STATE OF NORTH CAROLINA
DEPARTMENT OF TRANSPORTATION

Subject: **Modification to Section 404 Individual Permit and Section 401 Water Quality Certification and Neuse Buffer Certificate** for Northern Wake Expressway from NC 55 west of Morrisville to 0.7 km northeast of I-40 in Wake and Durham Counties (TIP Nos. R-2000AA, R-2000AB; and R-2000AC); State Project No. 8.U401711; Federal Aid Project No. NHF-123-1(11). USACE Action ID No. 200021863 (Previous Action ID. No. 199920387 and Action ID No. 199601917), NCDENR-DWQ Project No. 030918; \$475.00 Debit WBS Element 34365.1.2

The North Carolina Department of Transportation (NCDOT) is currently constructing a portion of the Northern Wake Expressway in Wake and Durham Counties (R-2000 Sections AA, AB and AC). The United States Army Corps of Engineers (USACE) originally issued an Individual Permit for this project on October 10, 1996. The USACE issued a permit modification for the construction of this project on November 25, 2003. The North Carolina Division of Environment and Natural Resources, Division of Water Quality issued the 401 Water Quality Certification No. 3439 (NCDENR-DWQ Project No. 030918) for this project on October 7, 2003

PLAN VIEW SITE 6

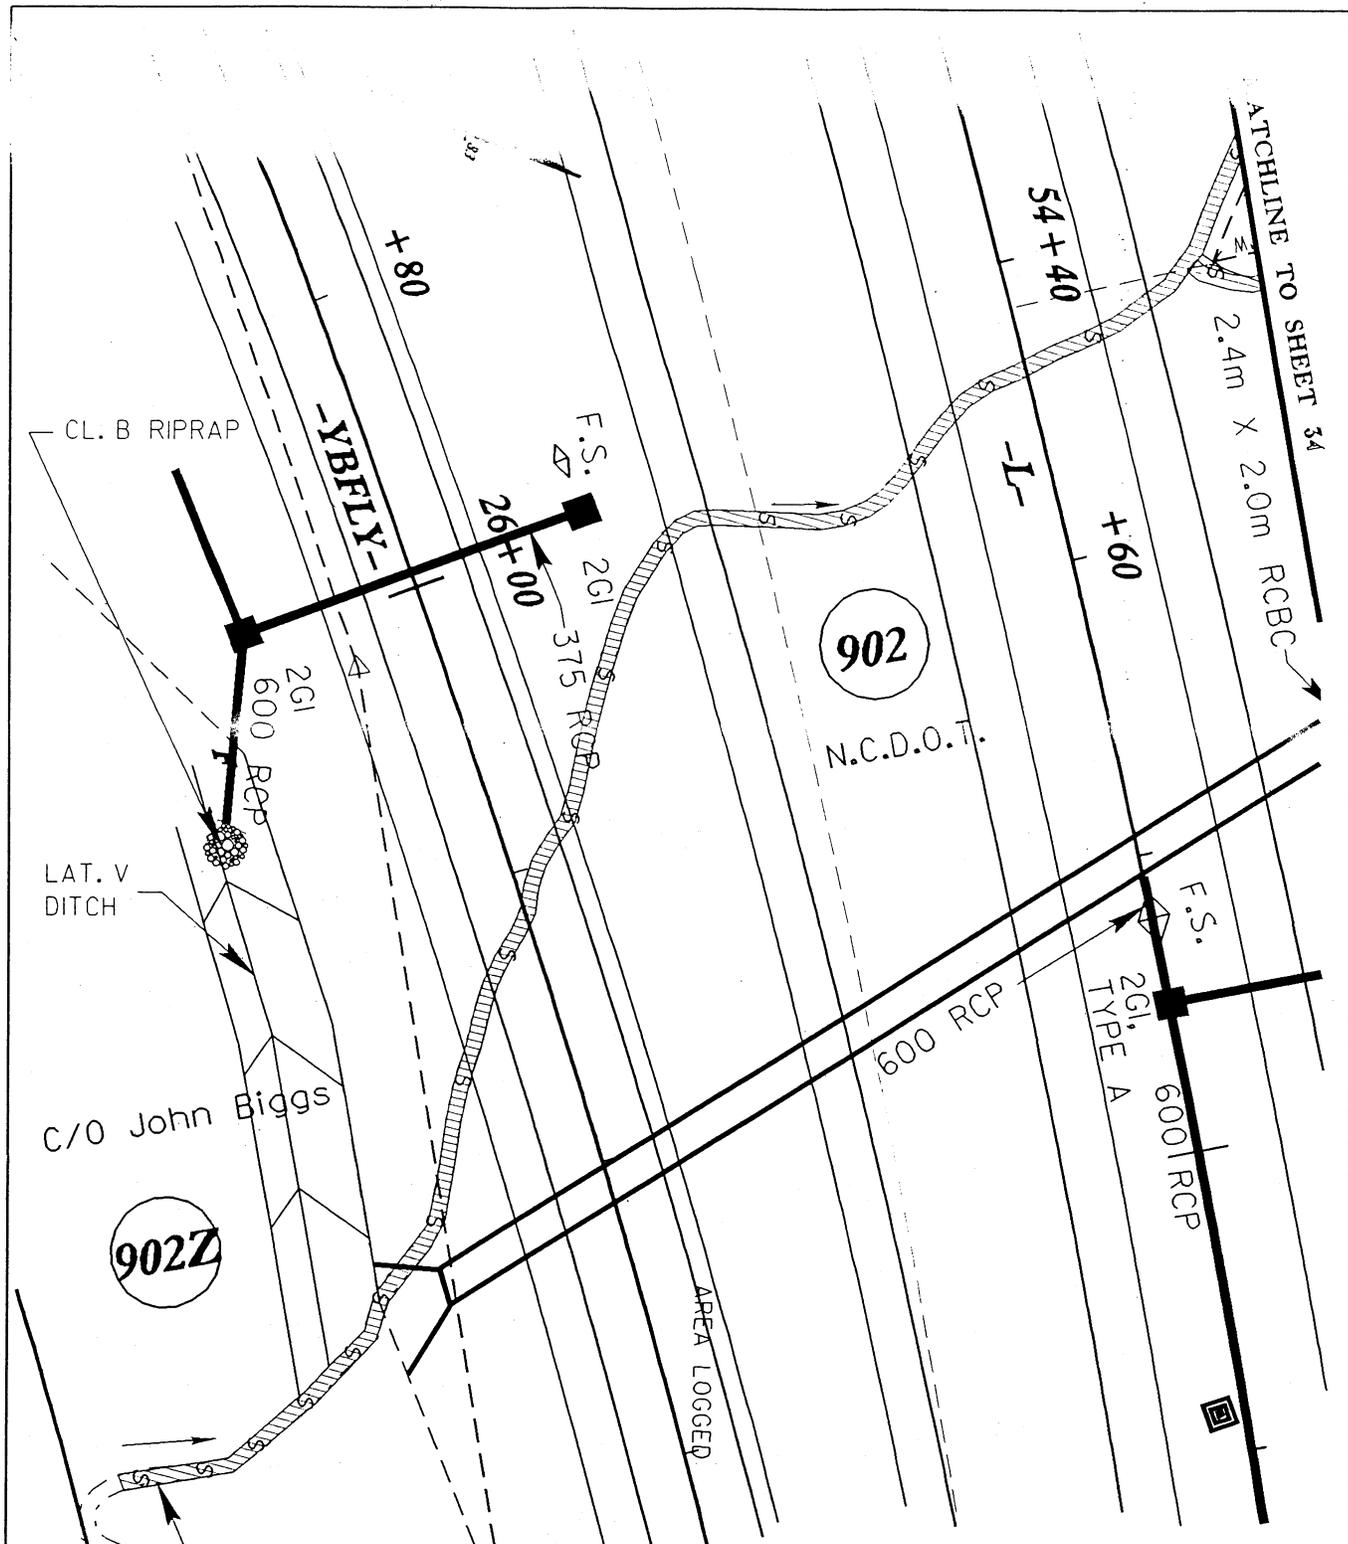
Issue: The plan sheets depicts a 375 mm reinforced concrete pipe at 51+90-L-. The permit drawing (7/03) does not depict this structure.

Status: Permit drawing has been modified (6/9/04) to depict the pipe.

Rev. SHEET 35 OF 67 6/19/00

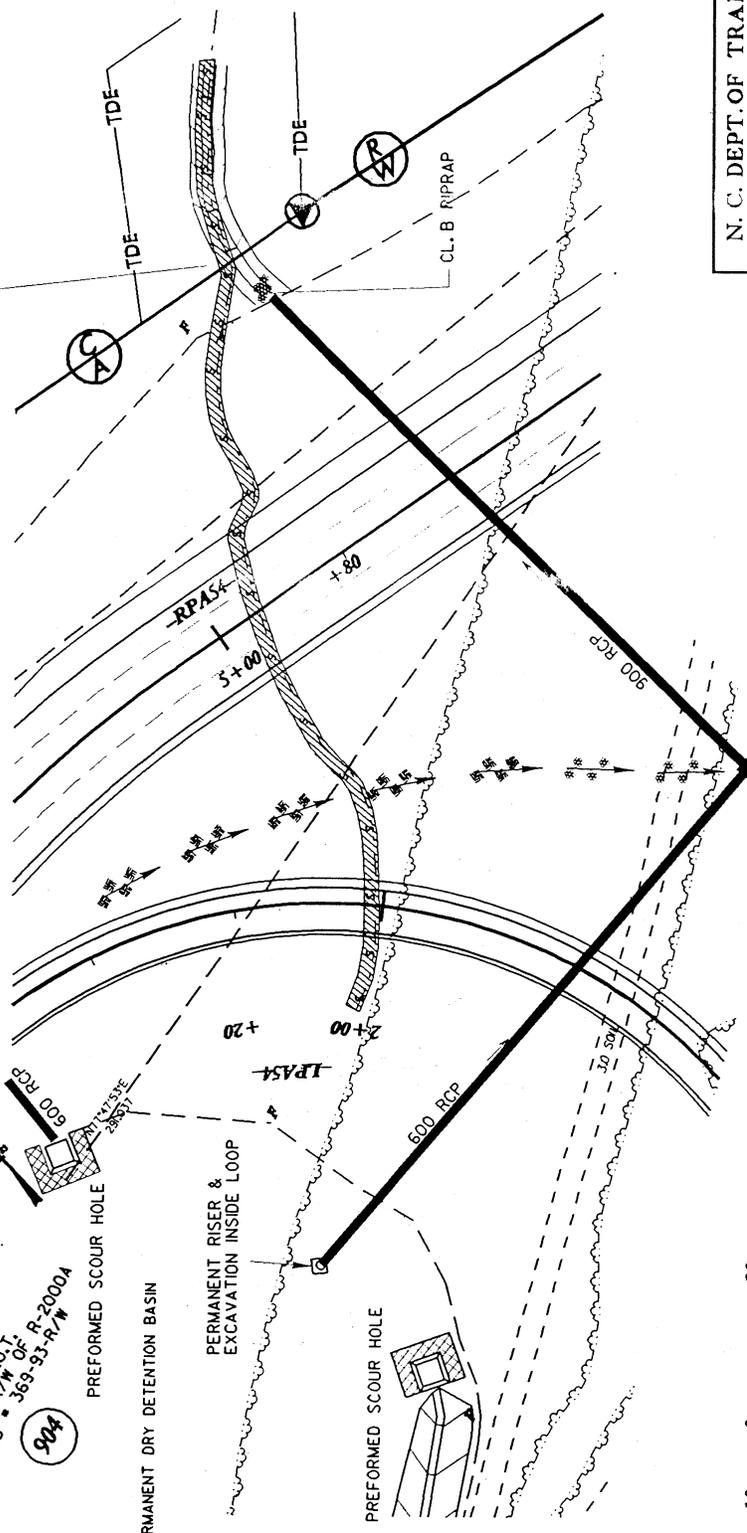
Issue: The tie in point of the temporary channel change at the inlet of the culvert as depicted on EC-5 is located outside of the permitted stream footprint as depicted on the permit drawing (7/03).

Status: Permit drawing has been modified (6/9/04) to depict revised stream impact at the inlet of the structure that will capture the tie in point of the temporary channel change.

Rev. 6 OF 12
SHEET 6 OF 12
6/9/04

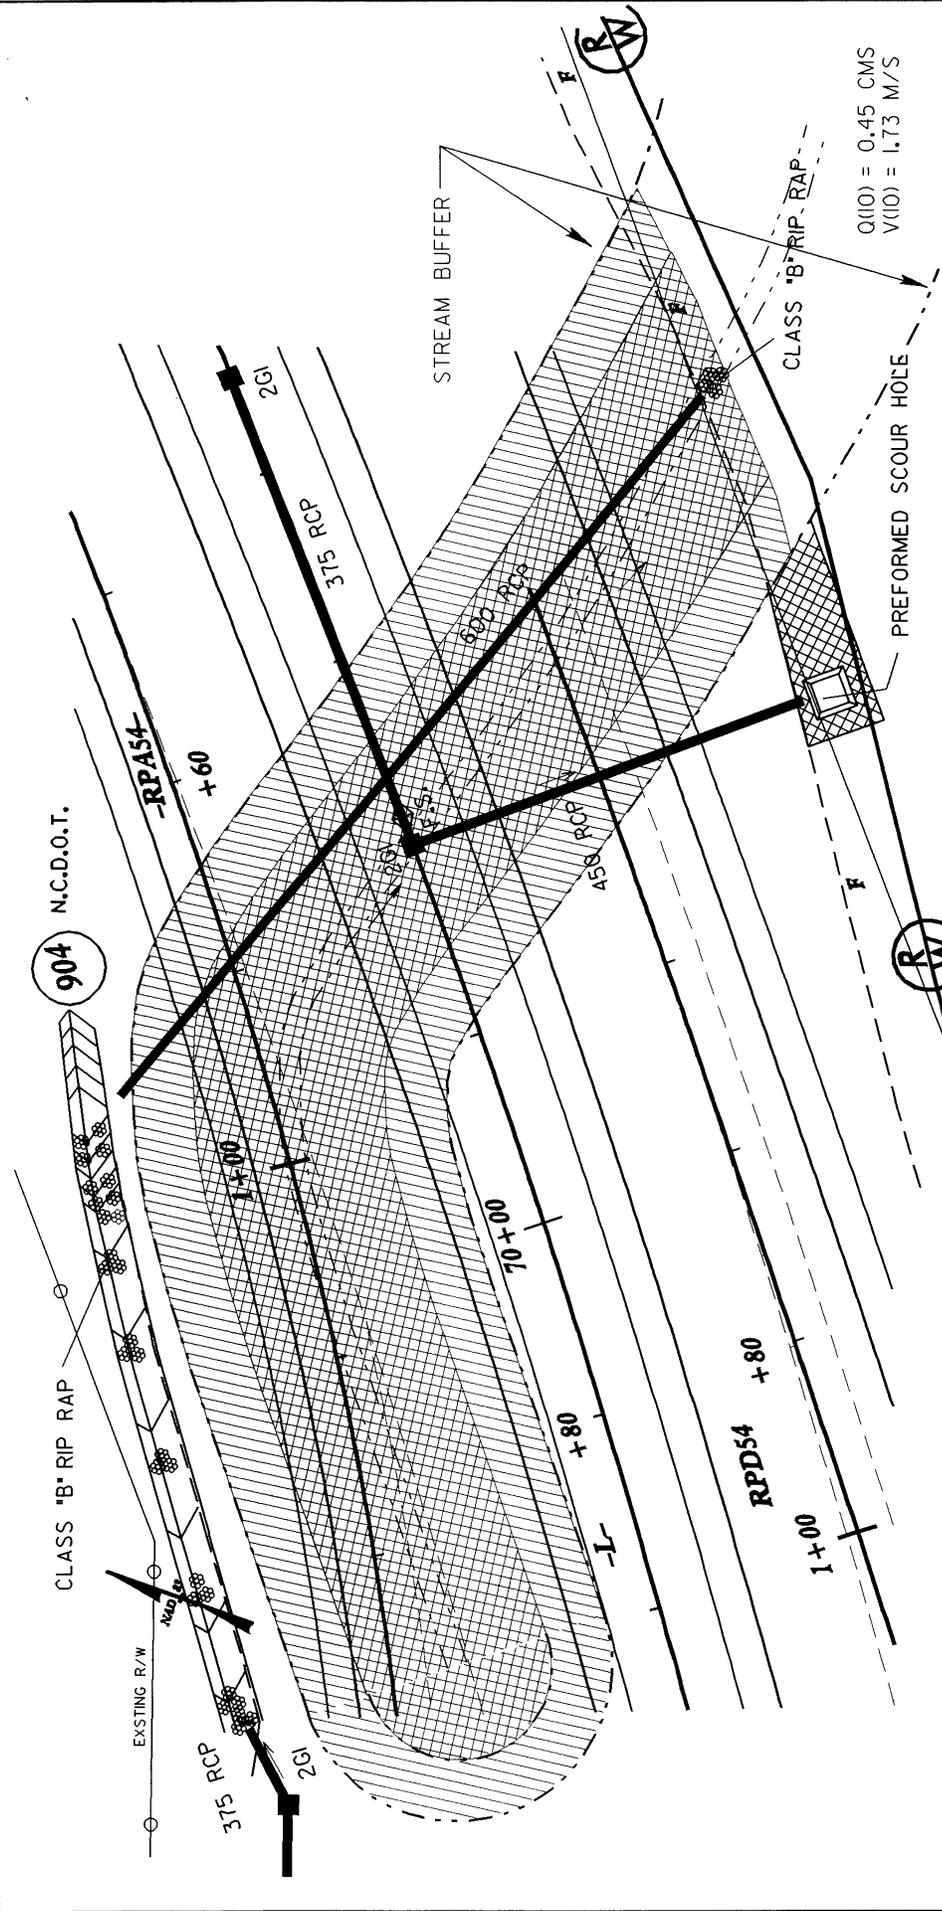
Issue: The plan sheet depicts a PFSH at the outlet of the lateral base ditch at 1+00 (inside loop A) -LPA54-. The PFSH was not depicted on the stream impact drawing (7/03) and the buffer impact permit drawing (4/03).

Issue: The plan sheet depicts a 600 mm reinforced concrete pipe and a PFSH at 2+70 (inside loop A) -LPA54-. The 600 mm reinforced concrete pipe and PFSH were not depicted on the stream impacts permit drawing (7/03) and the buffer impacts permit drawing (4/03).

Status: Both stream impact and buffer impact permit drawings have been modified (6/9/04) to depict the PFSH.

Status: Both stream impacts and buffer impacts permit drawings have been modified (6/9/04) to depict the 600 mm reinforced concrete pipe and the PFSH.

Rev. 8 OF 12 6/20/04
SHEET

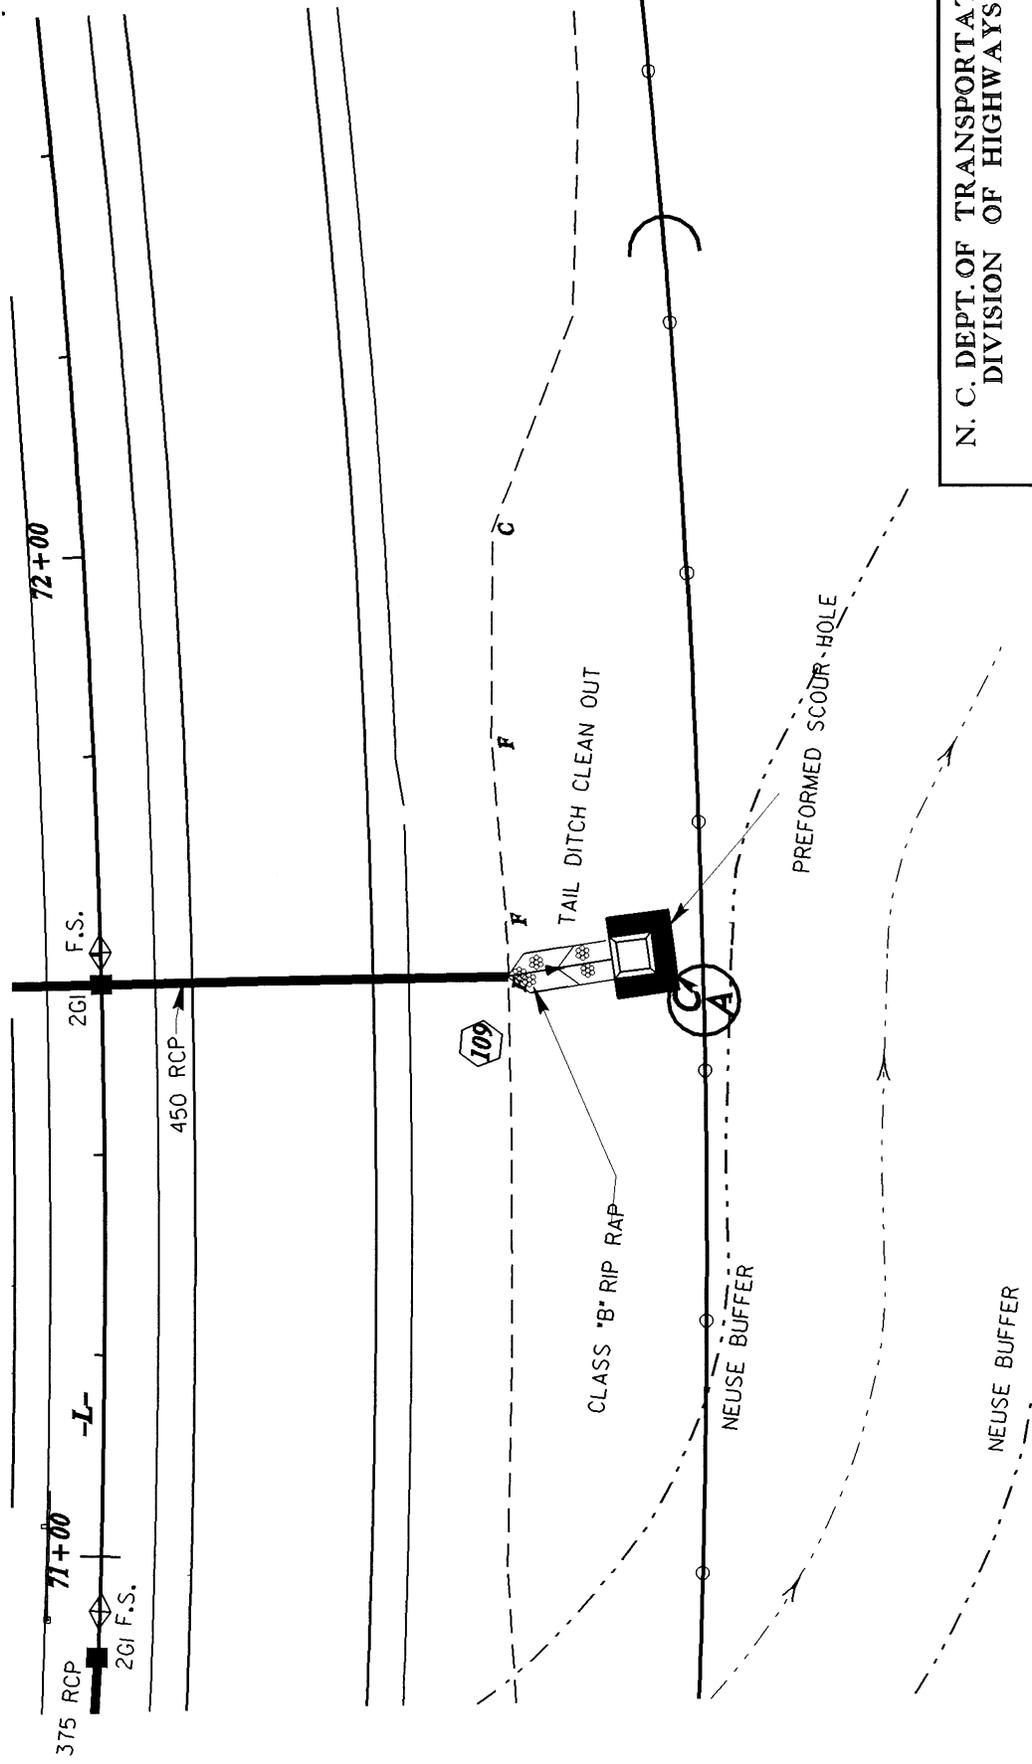
Issue: The plan sheet indicates a PFSH at Station 70+40 Rt. The buffer impacts permit drawing (4/03) depicts a PFSH incorrectly labeled as a level spreader at this location.

Issue: The plan sheet depicts a median drop inlets and median 375 mm reinforced concrete pipe from 70+40 to 70+90 -L-. The drop inlets and pipe are not depicted on the buffer impacts permit drawing (4/03).

Issue: The plan sheet depicts a 375 mm reinforced concrete pipe, drop inlet and lateral v ditch from 69+50 to 70+40 –Lt-. The drop inlet, pipe and ditch are not depicted on the buffer impacts permit drawing (4/03).

Issue: The plan sheet depicts a correctly sized 450 mm reinforced concrete pipe at 70+40 –L- that flows to the PFSH. The structure is depicted as a 375 mm reinforced concrete pipe on the buffer impact permit drawing (4/03).

Status: Buffer permit drawing has been modified (6/20/04) to correctly label the structure as a PFSH.

Status: The buffer impacts permit drawing (6/9/04) has been modified to depict the drop inlets and pipe.

Status: The buffer impacts permit drawing (6/9/04) has been modified to depict the drop inlet, pipe and ditch.

Status: The buffer impact permit drawing has been modified to depict the structure as a 450 mm reinforced concrete pipe.

SITE II

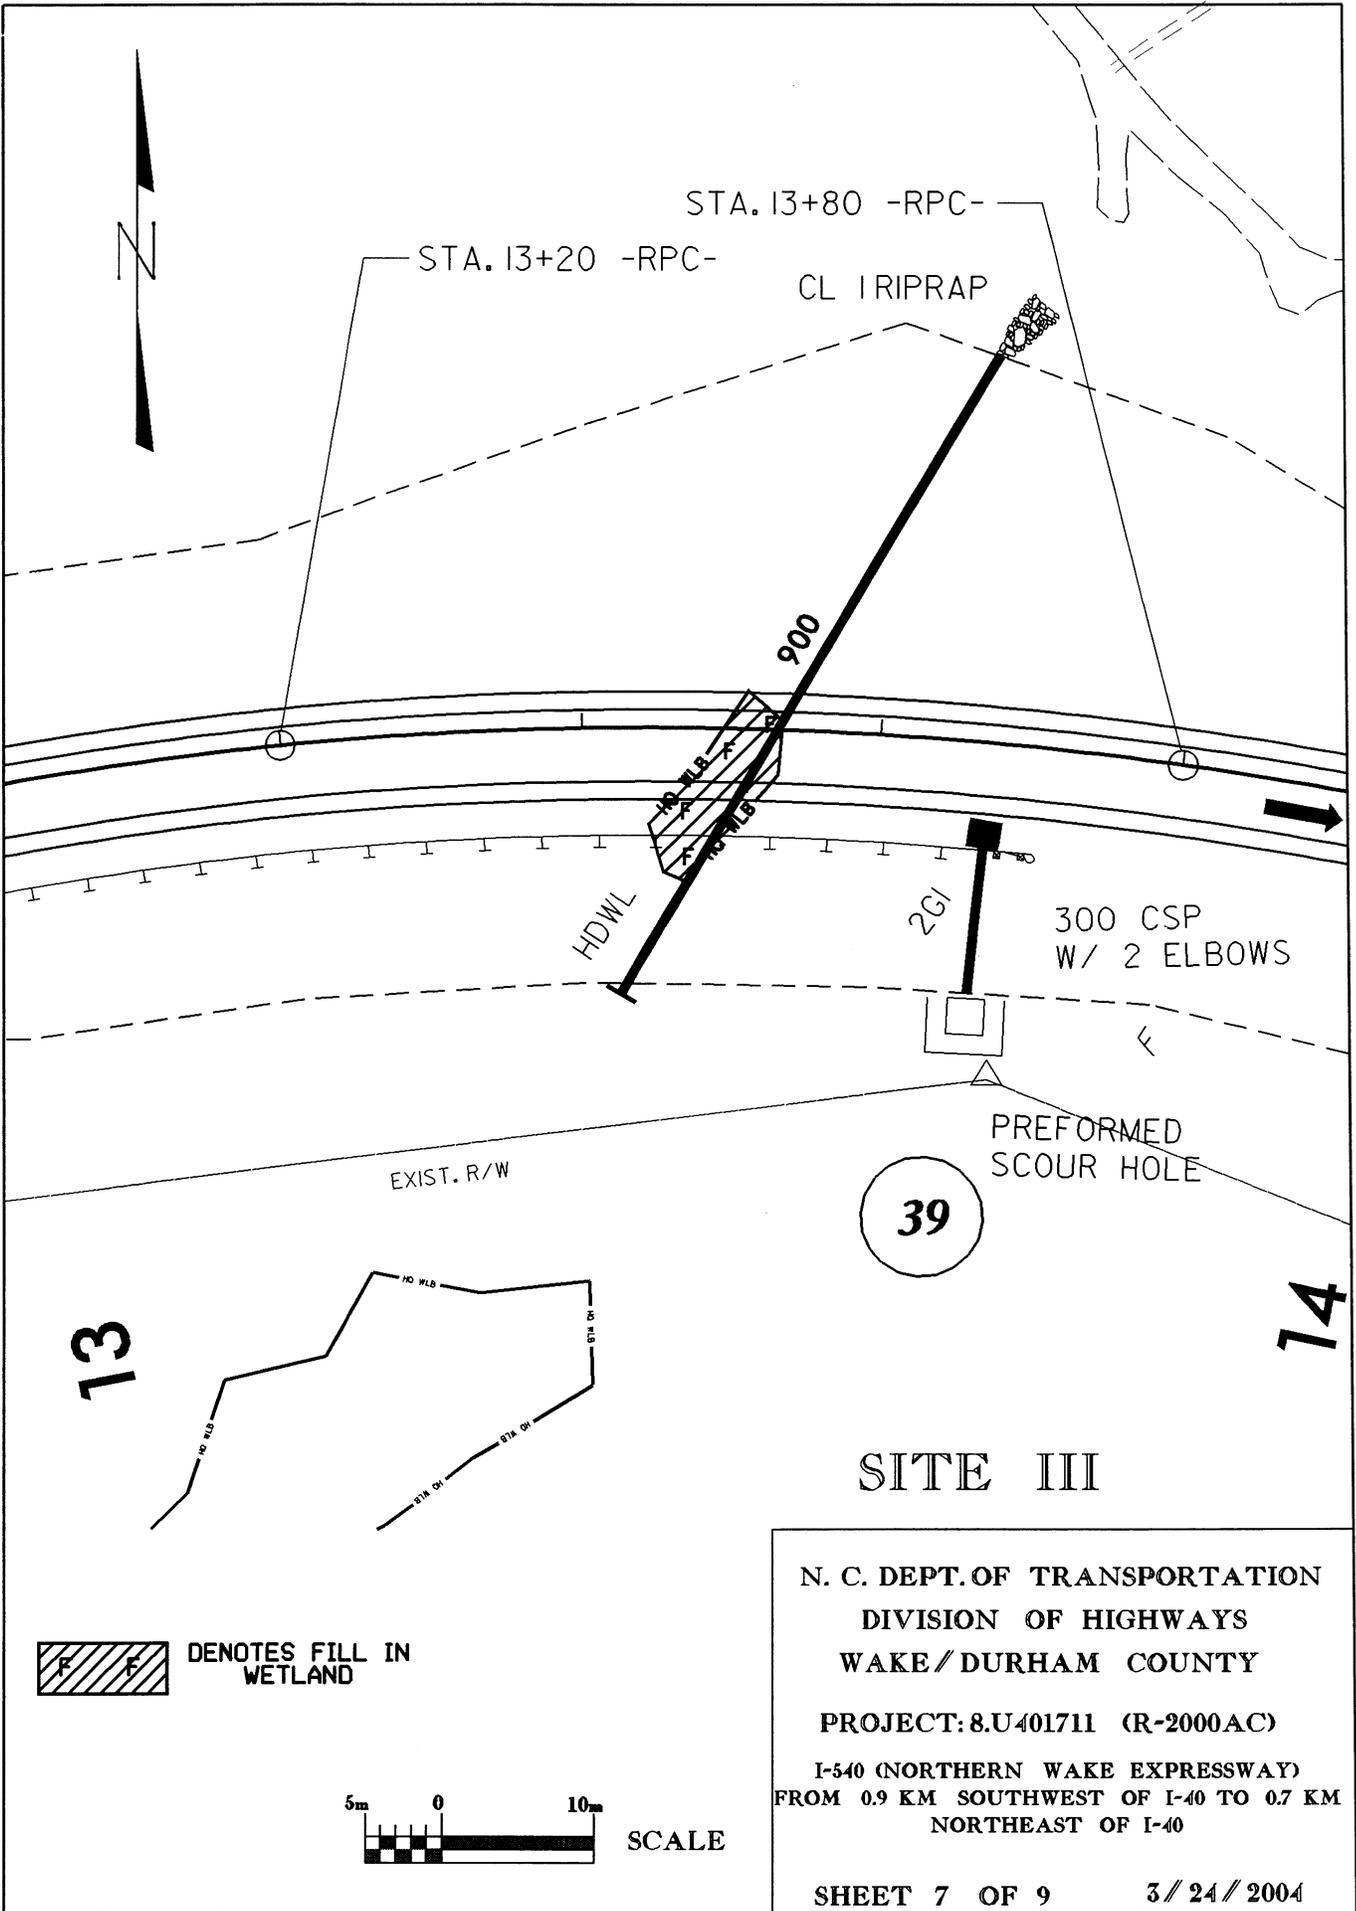
Issue: The stream impacts permit drawing (11/26/02), buffer impacts permit drawing (11/26/02) and plan sheets indicate that two lateral grass swales will be constructed along the southern toe of fill. A recent review of the site has indicated that Class I rip rap must be placed at the terminal portions of the swales inside the riparian buffer.

Status: The stream impacts permit drawing and buffer impact permit drawings have been modified (3/18/04) to depict the placement of the Class I rip rap in the lateral grass swales.
